Subject: AP1000 Response to Request for Additional Information (SRP 9)

# AP1000 TECHNICAL REPORT REVIEW

RAI Response Number: RAI-SRP 9.1.2-SEB1-05  
Revision: 1

RAI Response Number: RAI-SRP 9.1.2-SEB1-06  
Revision: 1

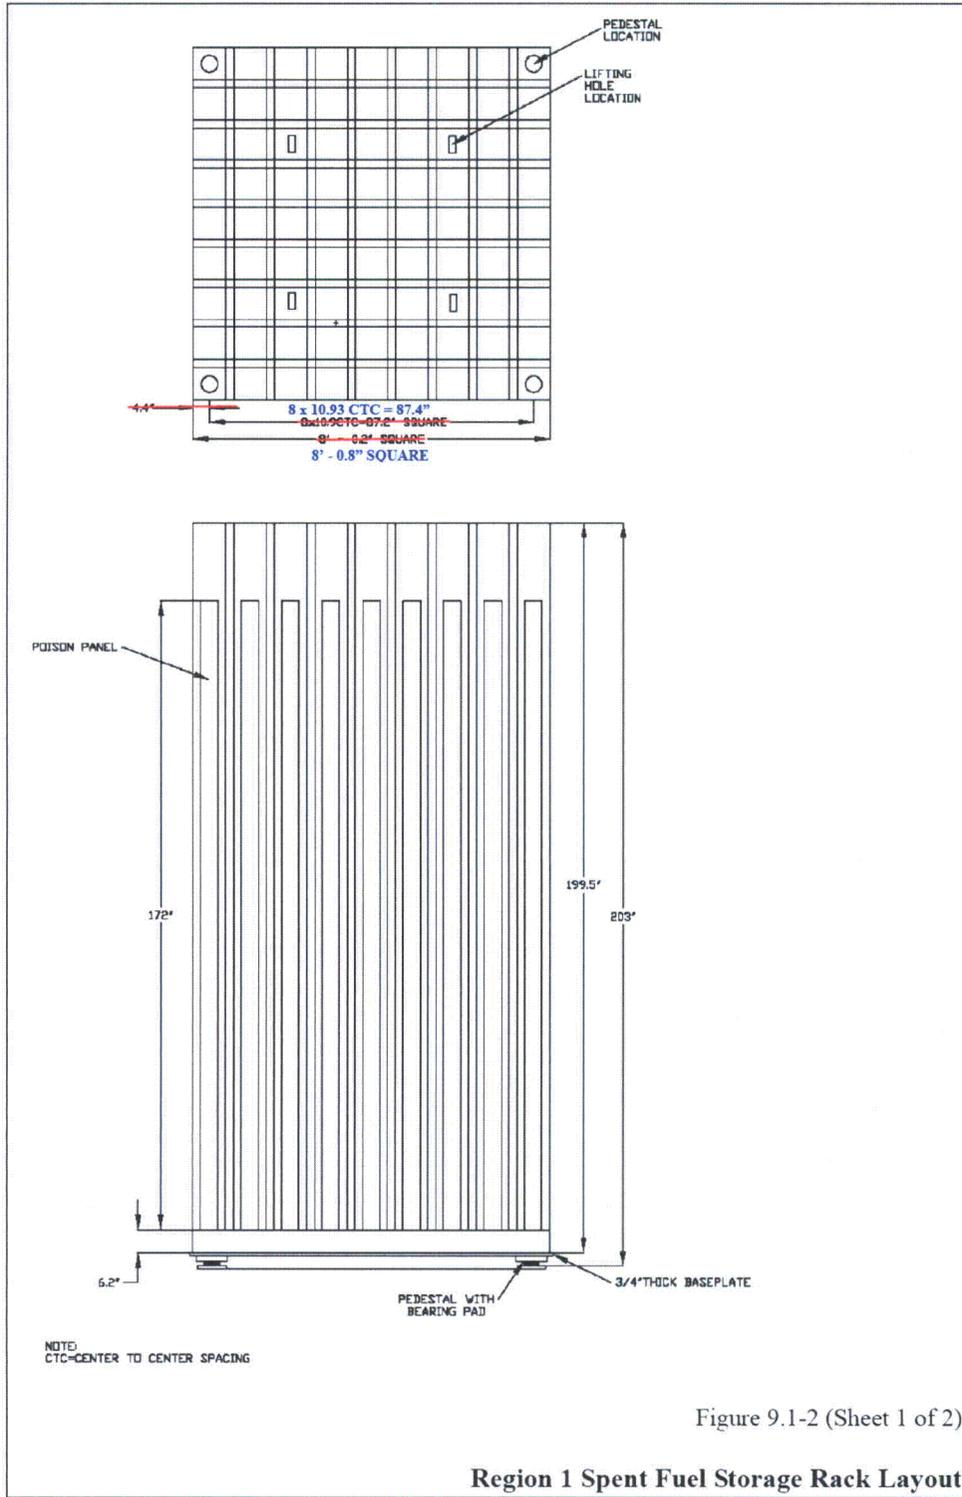
- Figure 9.1-2 (Sheet 1 of 2) of Rev. 17 of the DCD should be modified as follows:
  - The 4.4" dimension should be deleted, as it can be calculated from the other 2 dimensions provided, and it is inconsistent with the format of Figure 9.1-3.
  - 8x10.9CTC=87.2" SQUARE should be changed to 8 x 10.93 CTC = 87.4" SQUARE
  - 8' - 0.2" SQUARE should be changed to 8' - 0.8" SQUARE

• Figure 9.1-2 (Sheet 2 of 2) of Rev. 17 of the DCD should be modified as follows:

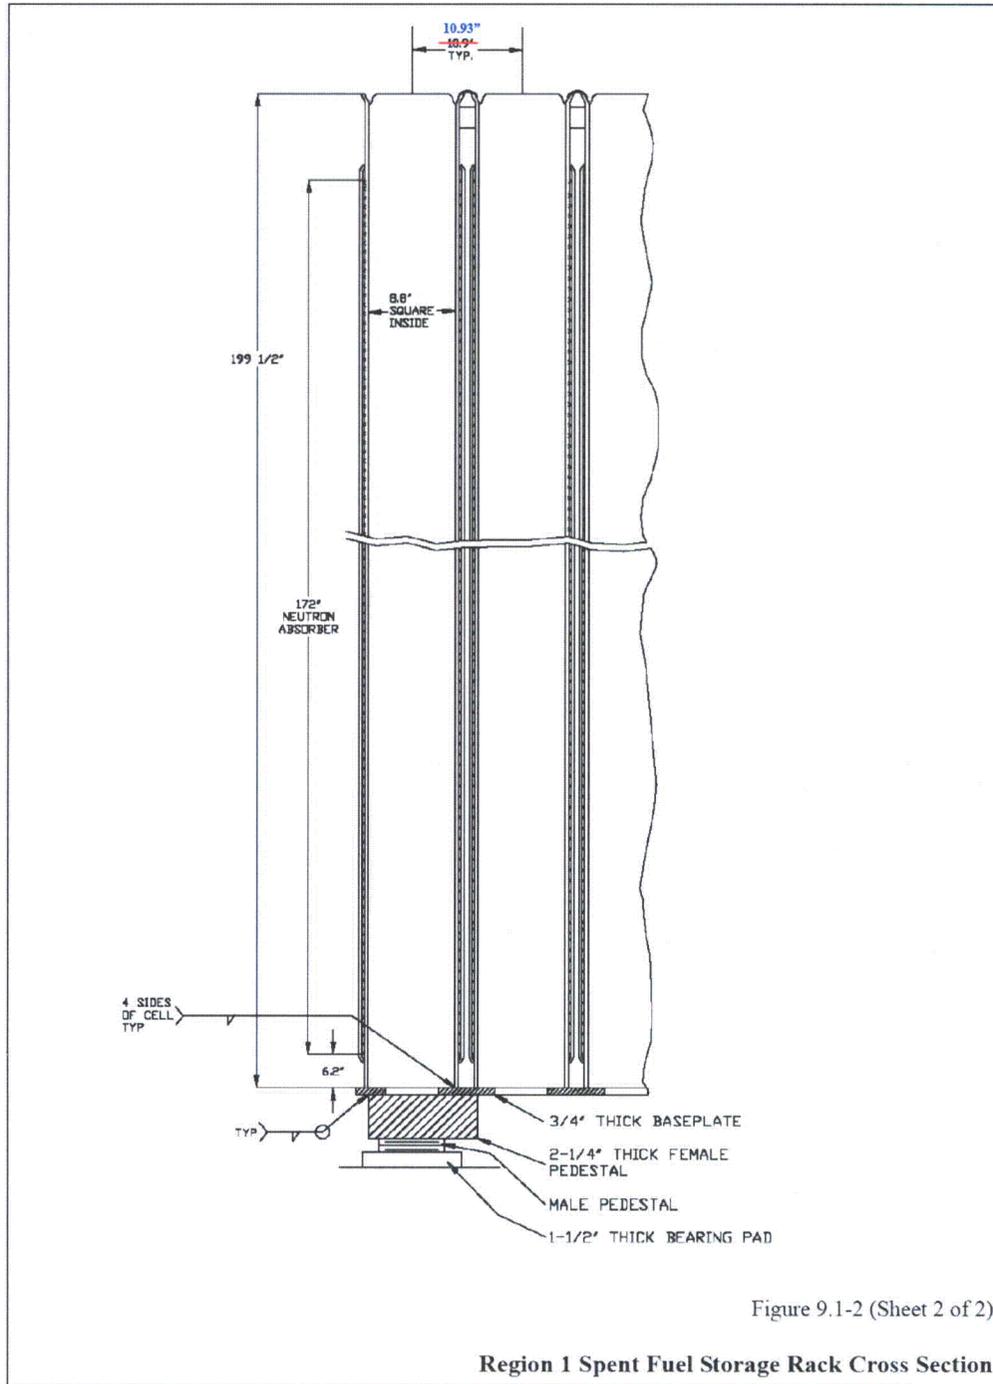
- 10.9" TYP. should be changed to 10.93" TYP.

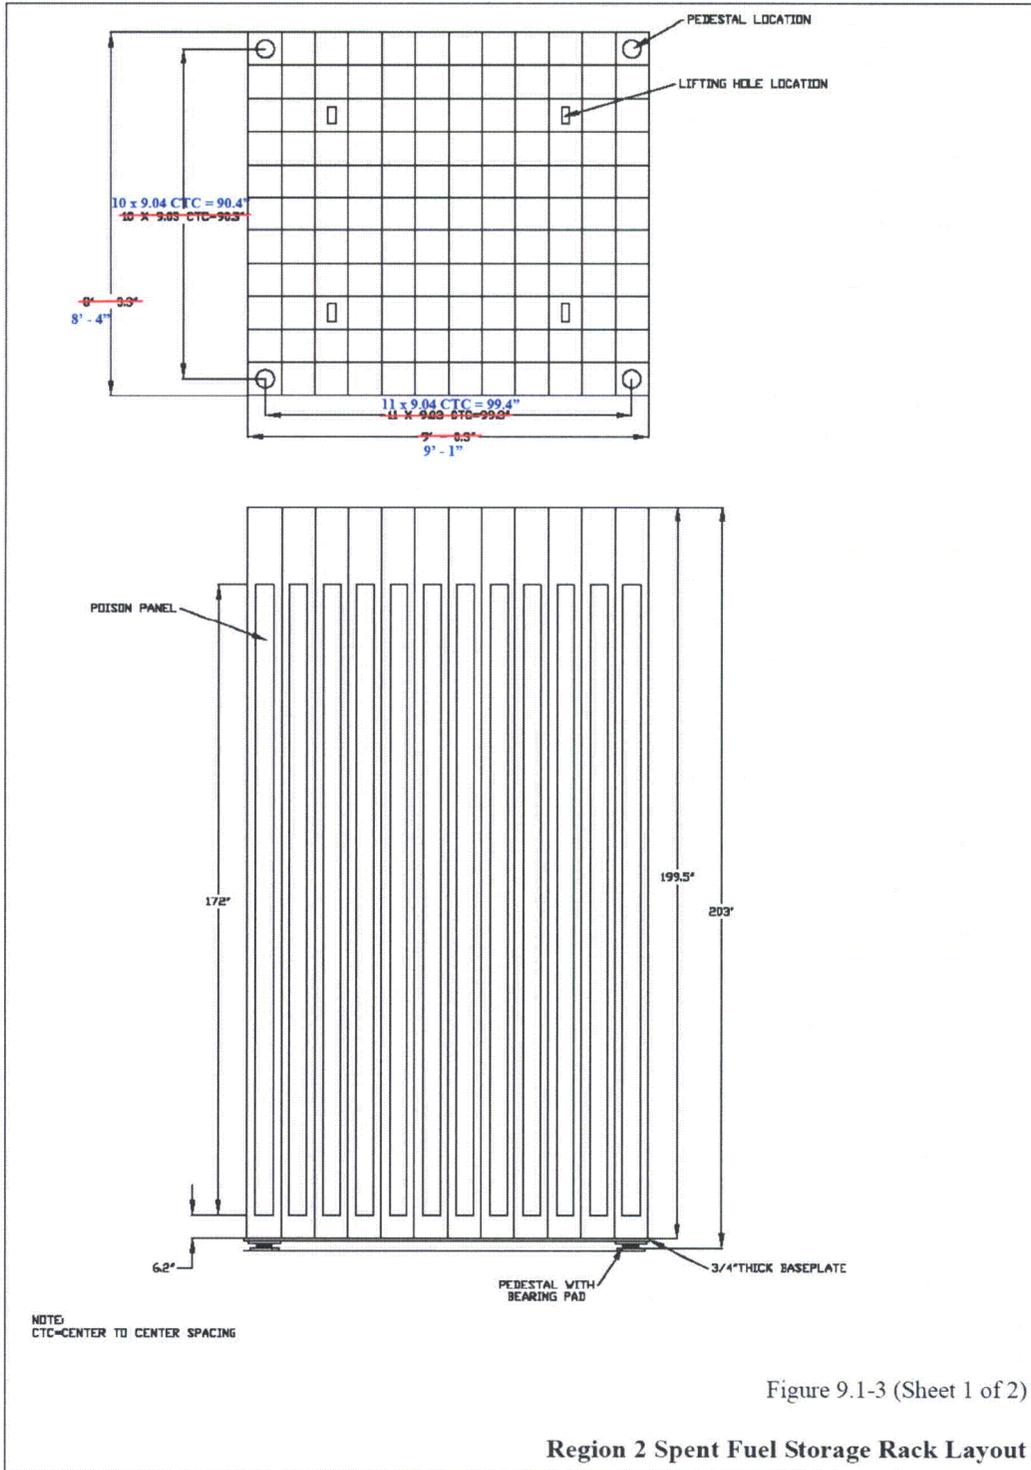
- Figure 9.1-3 (Sheet 1 of 2) of Rev. 17 of the DCD should be modified as follows:
  - 10 x 9.03 CTC=90.3" should be changed to 10 x 9.04 CTC = 90.4"
  - 8' - 3.3" should be changed to 8' - 4"
  - 11 x 9.03 CTC=99.3" should be changed to 11 x 9.04 CTC = 99.4"
  - 9' - 0.3" should be changed to 9' - 1"

• Figure 9.1-3 (Sheet 2 of 2) of Rev. 17 of the DCD should be modified as follows:

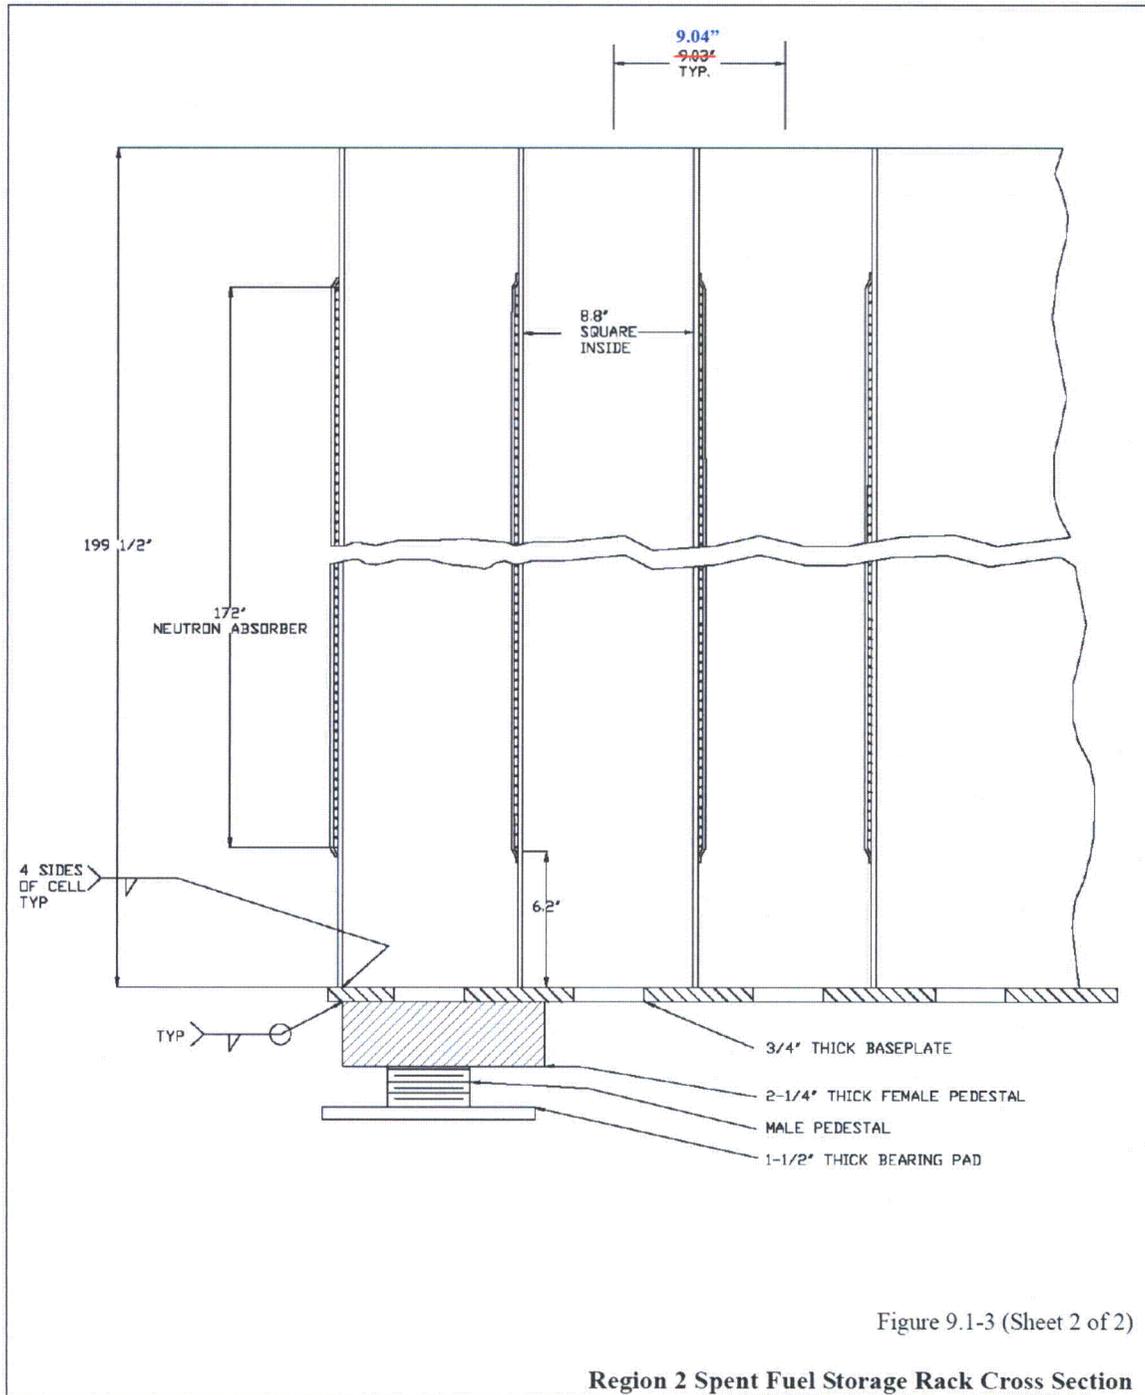
- 9.03" TYP. should be changed to 9.04" TYP.

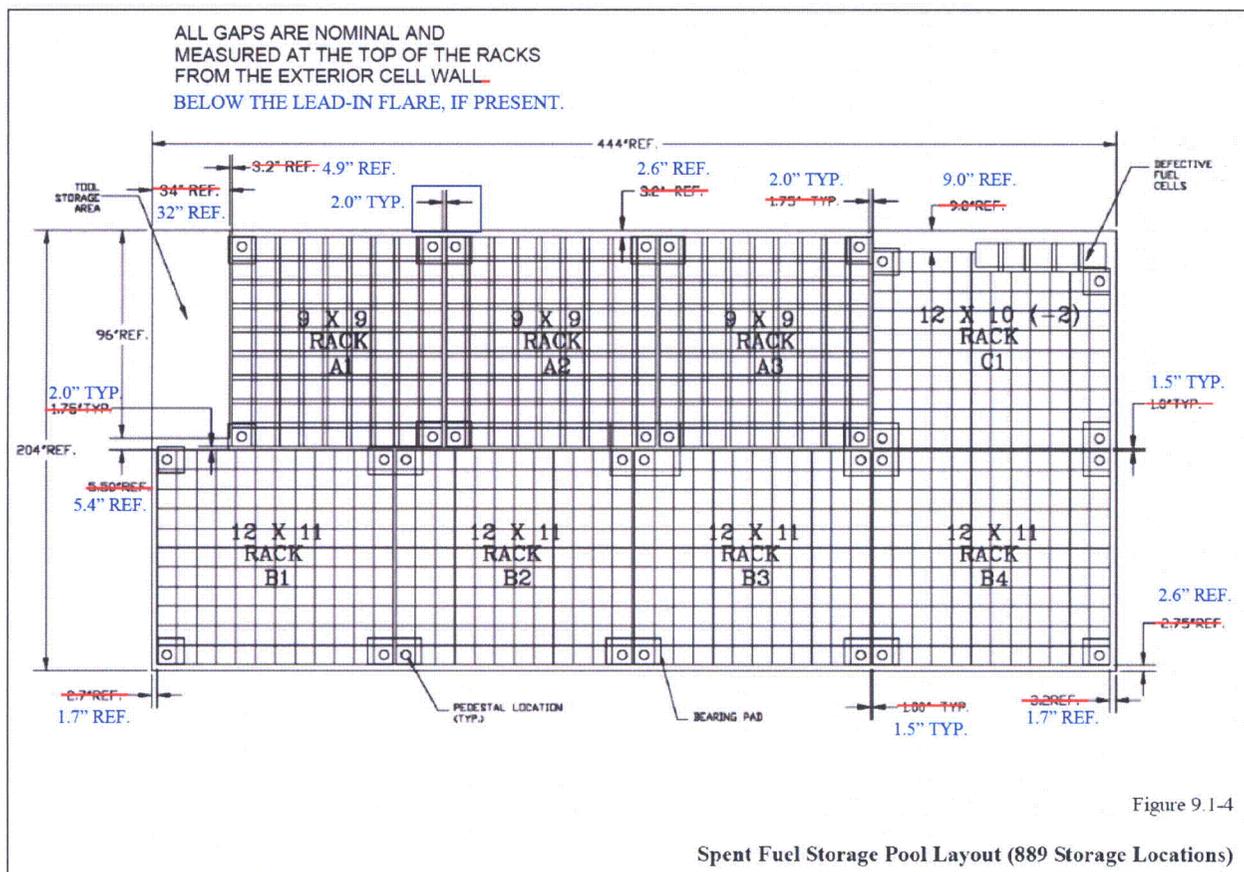
- The placement of the racks within the spent fuel pool is being modified to account for the aforementioned changes and to optimize the gaps such that the impacts (both rack-to-rack and rack-to-wall) are minimized. The slightly modified pool layout is shown in the markup of DCD Figure 9.1-4 on the following page.

- Figure 9.1-4 and Technical Specification Figure 4.3-1 of Rev. 17 of the DCD should both be modified as follows:
  - Details are included in the marked-up figure.
  - (Note that a previous Westinghouse approved design change modified this figure to change the 34" tool storage area and corresponding 3.2" gap to Rack A1 to 33" with a 4.2" gap.) These dimensions are now changed to make the tool storage area width 32" and the gap to Rack A1 distance 4.9".
